Road Safety Audit Report

**Incorporating
Stage 1 Completion of Preliminary Design;
Design Organisation Response to items raised; and
Auditors View of Design Organisation Response.**

Proposed Roundabout and footway link Newgate Lane East Fareham

Job no	RSA-21-110	Issue no	6	Date	July 2022
Prepared by	JJF	Verified by	ZB	Approved by	JJF
Filename and Path	Fenley/Road Safety Audits/RSA-21/RSA-21-110-6

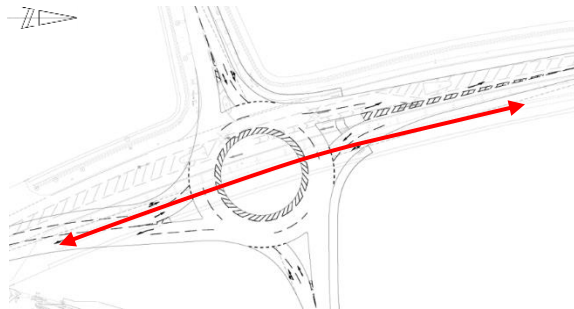
A.2	GENERAL
A.2.1	PROBLEM
Location:	Newgate Lane East
Summary:	No details of the proposed drainage have been provided at this stage
Acc Type:	Sideswipes and loss of control type collisions
<p>Newgate Lane East is a relief road and benefits from a drainage ditch beyond a grass verge either side. Surface water that falls on the carriageway is understood to flow through a number of existing channels that are cut into the adjacent verge. The proposals that are subject to this Stage 1 Road Safety Audit include the provision of a four-arm roundabout and the realignment of the Newgate Lane East approaches. The proposed highway is to be provided where the existing ditches are present. Whilst levels have been provided on the topographical survey and along the centreline of the proposed carriageway, no details associated with the proposed contours or</p>

drainage have been provided at this stage. It can be assumed that the existing ditch is to be removed and that surface water will fall along the carriageway in accordance with the levels, however, an insufficient surface water drainage network could lead to ponding being observed which could result in loss of control type collisions especially during frosts.

It is recommended that an adequate surface water drainage network is provided

Agreed – diversion and culverting of the existing highway drain subject to OWC consent and to be discussed and agreed with HCC at detailed design stage to ensure adequate water drainage network is provided. Drawing ITB10353-GA-102 Rev A illustrates the likely ditch diversion and culverting that is expected to be required. *(It should be noted that the scheme has been revised to take account of items raised by HCC and the latest scheme Drawing is ITB10353-GA-102 Rev E. However, these changes do not affect this item raised)*

Confirmation that the ditch is to be diverted and culverted, addresses the road safety concern raised at this stage provided sufficient clearance is provided between the carriageway and diverted ditch.

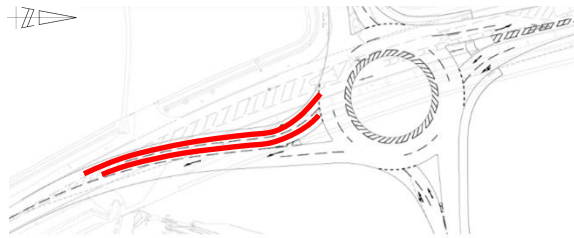
A.2.2	PROBLEM
Location:	Newgate Lane East
Summary:	Vehicles may accelerate and overtake on approach to the roundabout
Acc Type:	Junction overshoot, heavy braking and loss of control type collisions
<p>Newgate lane East is a wide single carriageway two-way road that is subject to a 40mph speed limit and observes a traffic flow of circa 2400 during the morning and afternoon peak hours. The proposals that are subject to this Stage 1 Road Safety Audit include the provision of a four-arm roundabout along Newgate Lane East at the existing Newgate Lane priority junction. The scheme drawings provided with the Audit Brief illustrate that the carriageway width of the northbound Newgate Lane East approach to the roundabout increases to two 3.5 metre lanes from a point 70</p>

metres from the give-way line. Whilst the information included within the Audit Brief identifies that the layout allows for two HGV's to enter the proposed roundabout side by side, no swept path of the approach is included. It is noted that the traffic flow data within the Junctions 10 data also provided with the Audit Brief, shows that the HGV content of southern arm of Newgate Lane East makes up just 2% of vehicles and therefore the likelihood of two large vehicles travelling through the junction side by side is negligible. The Audit Team have concerns that the wide two-lane approach will lead to high-speed approaches and be utilised for overtaking manoeuvres leading to heavy braking and loss of control or overshoot type collisions.

It is recommended that the width and length of the two-lane approach is reduced

Following further consultation with the County Highway Authority and as requested, the background growth in traffic was increased. As a result, the junction was re-modelled utilising the Junctions 10 software to ensure that the geometry of the proposed roundabout was sufficient to ensure operational capacity during future years. As can be seen in the full results provided with this response, an 88 metre flare is required along the northbound approach to the roundabout which will allow the proposed roundabout to operate effectively and within capacity following all expected development within the area by the year 2037. The northbound exit from the roundabout accommodates two lanes that merge to the existing single lane with a taper in excess of 1 in 20 which as stated in the Design Manual for Roads and Bridges at paragraph 3.28.7 of CD116, 'can help merge the traffic where the density in each lane is high'.

The Audit Team understand that the proposed two-lane approach is required for capacity purposes which will allow the proposed roundabout to operate effectively in future years and that an adequate merge is provided on the northbound exit from the roundabout. Confirmation within the Design Organisation Response to item A.1.1; that the level of deflection on the northbound approach equates to 95 metres and to items A.2.3, A3.2 and A.5.2; that bollards, chevron signs and street lighting are to be provided, should ensure that all traffic even any vehicles attempting

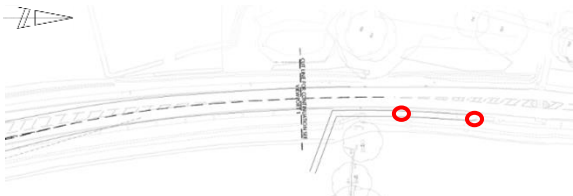
A.4.1 PROBLEM

Summary: Pedestrians may enter the live carriageway when it is not safe to do so

Newgate Lane benefits from a footway along the western side of the carriageway that provides a link between Fareham to the north and Lee-on-the-Solent to the south. The proposals that are subject to this Stage 1 Road Safety Audit include the provision of a roundabout along Newgate Lane East that accommodates a shared footway cycleway between the eastern and western arms along the northern side of the carriageway and across the northern Newgate Lane East arm. The scheme drawings provided with the Audit Brief illustrate that an uncontrolled crossing is to be provided across the Newgate Lane cul-de-sac with a footway link to the west that approaches inline which will lead to pedestrians walking directly towards the crossing point. Tactile paving is provided to warn pedestrians of the live carriageway, however, just two rows are illustrated on the scheme drawing equating to a dept of 800mm. A pedestrian with a large stride or walking at a fast pace towards the proposed crossing point, could overstep the proposed tactile paving into the path of an approaching vehicle leading to a vehicle pedestrian collision.

RECOMMENDATION:	
It is recommended that the tactile paving extends for a minimum depth of 1200mm at crossing points that are inline	
Location Plan:

DESIGN ORGANISATION RESPONSE provided by i-Transport on the 2 nd December 2021 following formal issue of this Stage 1 Road Safety Audit on the 22 nd November 2021	
Agreed – tactile paving has been revised to provide 1200mm depth at crossing points identified. Drawing ITB10353-GA-102 Rev A has been updated to reflect these design changes. <u>(It should be noted that the scheme has been revised to take account of items raised by HCC and the latest scheme Drawing is ITB10353-GA-102 Rev E. However, these changes do not affect this item raised)</u>	
AUDITOR'S VIEW OF DESIGN ORGANISATION RESPONSE dated 6 th December 2021	
Confirmation that the depth of the tactile paving has been increased, addresses the road safety concern raised at this stage.	
A.4.2	PROBLEM
Location:	Newgate Lane East
Summary:	Existing street lighting column is situated within the proposed footway
Acc Type:	Pedestrian collision with column

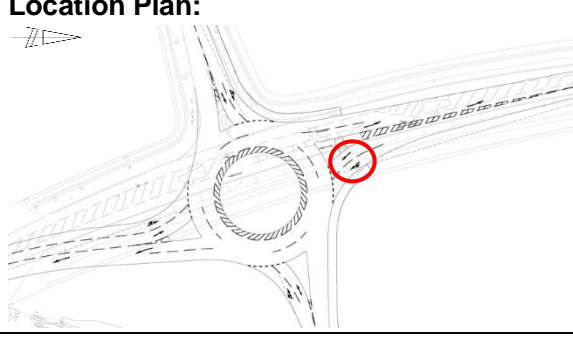
A.5	TRAFFIC SIGNS, CARRIAGEWAY MARKINGS AND LIGHTING
A.5.1	PROBLEM
Location:	Newgate Lane East
Summary:	The arrow road markings across the uncontrolled crossing point may be misinterpreted by visually impaired pedestrians
Acc Type:	Sideswipes and loss of control type collisions
<p>The proposals that are subject to this Stage 1 Road Safety Audit include the provision of a four-arm roundabout along Newgate Lane East that is to accommodate two-lane approaches as well as splitter islands on each arm to include across the northern arm that is to be utilised as a refuge for cyclists and pedestrians at an uncontrolled crossing point that benefits from tactile paving. The scheme drawings provided with the Audit Brief illustrates that arrow road markings are to be provided within each lane on approach to the roundabout give-way, however, the markings provided on the northern approach are situated on the carriageway where pedestrians and cyclists are likely to be crossing. The Audit Team have concerns that the arrow road markings across the uncontrolled crossing point may be misinterpreted by visually impaired pedestrians who may walk into the path of an approaching vehicle and slippery to walk on during frosts leading to a fall and personal injury.</p>

RECOMMENDATION:	
It is recommended that the road markings are marginally relocated outside the uncontrolled pedestrian crossing.	
Location Plan:

<p>DESIGN ORGANISATION RESPONSE provided by i-Transport on the 2nd December 2021 following formal issue of this Stage 1 Road Safety Audit on the 22nd November 2021</p>	
<p>Agreed – the road markings have been removed outside of the uncontrolled crossing and updated design presented in Drawing ITB10353-GA-102 Rev A. <i>(It should be noted that the scheme has been revised to take account of items raised by HCC and the latest scheme Drawing is ITB10353-GA-102 Rev E. However, these changes do not affect this item raised)</i></p>	
AUDITOR'S VIEW OF DESIGN ORGANISATION RESPONSE dated 6 th December 2021	
<p>Confirmation that the road markings have been marginally relocated, addresses the road safety concern raised at this stage.</p>

Item Location Plan

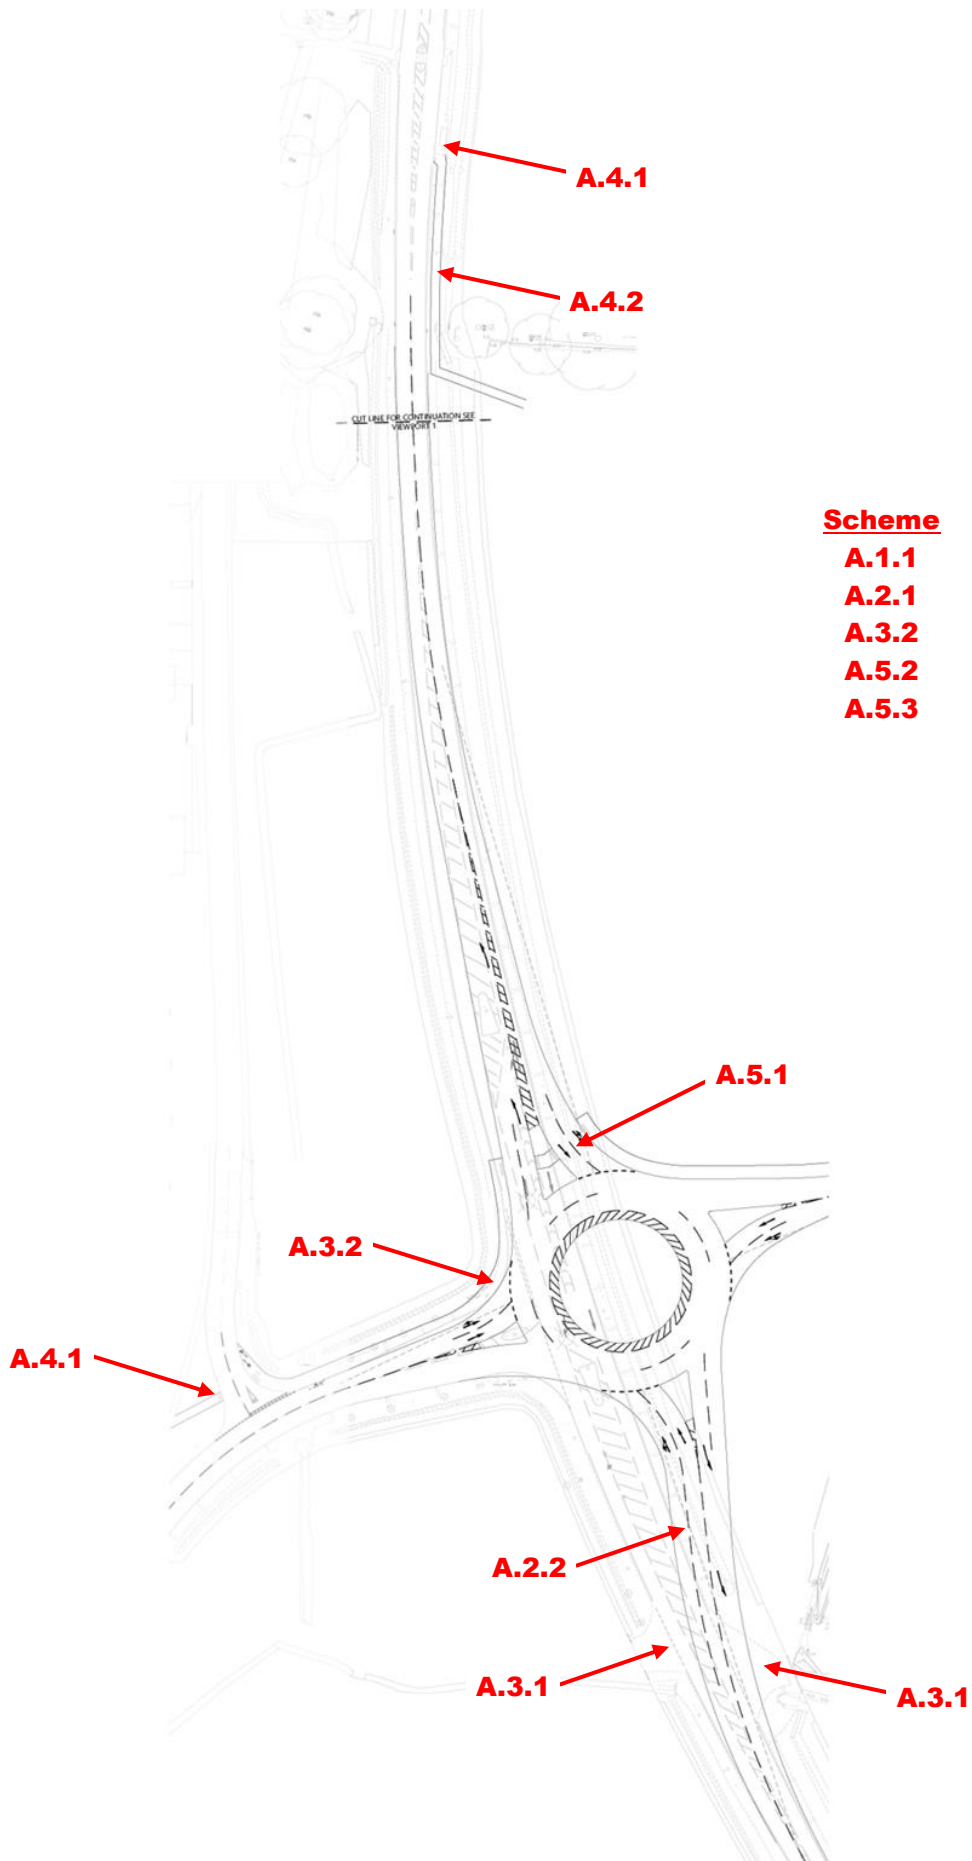
- 2.7 The terms of reference of this Road Safety Audit are as described in GG119. The scheme has been examined and this report compiled, only with regard to the safety implications for road users of the scheme as presented. It has not been examined or verified for compliance with any other standards or criteria. However, in order to clearly explain a safety problem or the recommendation to resolve a problem, the Audit Team may on occasion have referred to a design standard for information only. All comments and recommendations are referenced to the design drawings supplied with the Audit Brief and the location of road safety concerns raised have been illustrated beneath the items along with relevant photographs for clarity, where appropriate, as well as on the Location Plan attached at **Appendix A2**.
